### MEMORANDUM

**SUBJECT:** Plan Case No. 1931-S-05, Preliminary Plat for Water's Edge Subdivision located at

the northwest corner of High Cross Road / IL Route 130 and Stone Creek Boulevard.

# An Ordinance Approving A Preliminary Subdivision Plat (Water's Edge Subdivision - Plan Case No. 1931-S-05)

<u>Section 2.</u> Sidewalks for the Water's Edge Subdivision shall be provided as illustrated on the attached map entitled Land Use and Alternative Sidewalk Plan.

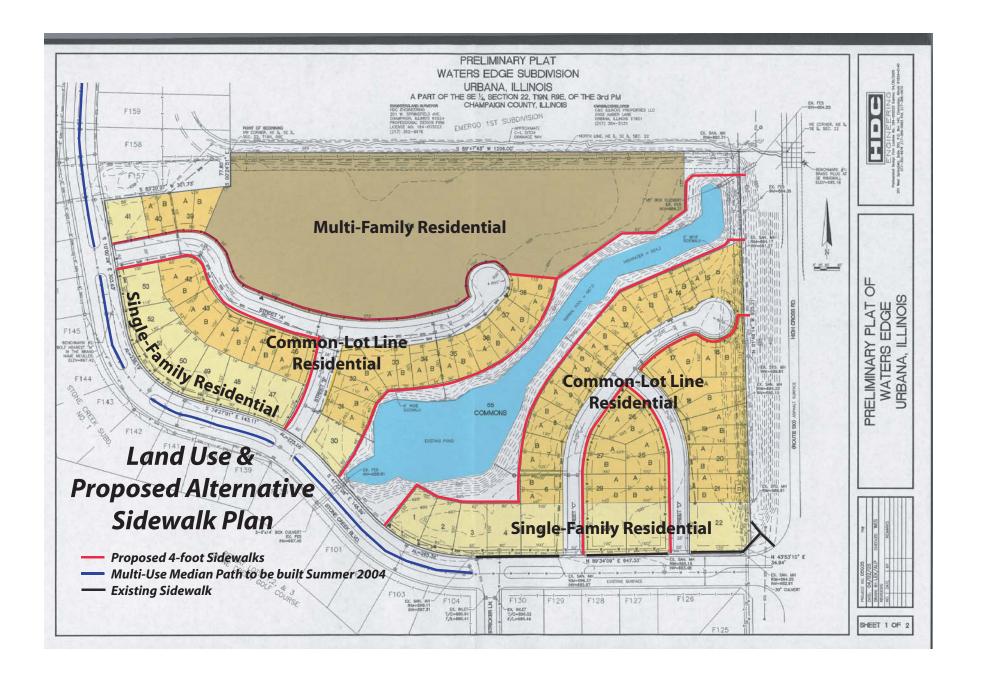
Mr. Hopkins went on to discuss the southwest end of the lake. He believed it would be desirable to continue the sidewalk, so people would be able to walk around the lake. Mr. Kowalski stated that staff had talked about requiring the developer to loop the sidewalk around the lake. By looping the sidewalk around the lake, it would prevent the sidewalk from ending at the curve in two points. Mr. Hopkins agreed that this would solve two of his concerns.

Mr. Pollock pointed out that lots 47 through 53 would only have access to the multi-use path along Stone Creek Boulevard. It appeared that there would not be any sidewalk connected in front of these lots. The same went for lots 18 through 22. Mr. Hopkins noted that lots 18 through 22 would have use of the City's multi-use path that would be located behind the lots along High Cross Road. Mr. Kowalski added that this was not unique to this development. This was the preferred sidewalk layout throughout the Stone Creek Subdivision.

Mr. Kangas wondered why there were hitches in the sidewalk around the lake. Mr. Creek explained that there were setbacks from the lake. There was not really a design pattern to the sidewalk layout around the lake other than that it fits the rear lot lines.

Mr. Hopkins commented that people would not actually walk on the sidewalk between lot 6-A/B and lot 4. He believed people would cut across. It might be work rethinking the sidewalk layout in this particular spot.

Mr. Hopkins moved that the Plan Commission forward this case to the City Council with a recommendation for approval with the condition that the sidewalk layout be changed to curve around the lake and to connect from the west edge of lot 1 to the southeast side of lot 30 and continue down to connect to the intersection with Street B. Ms. Goscha seconded the motion. Roll call was as follows:
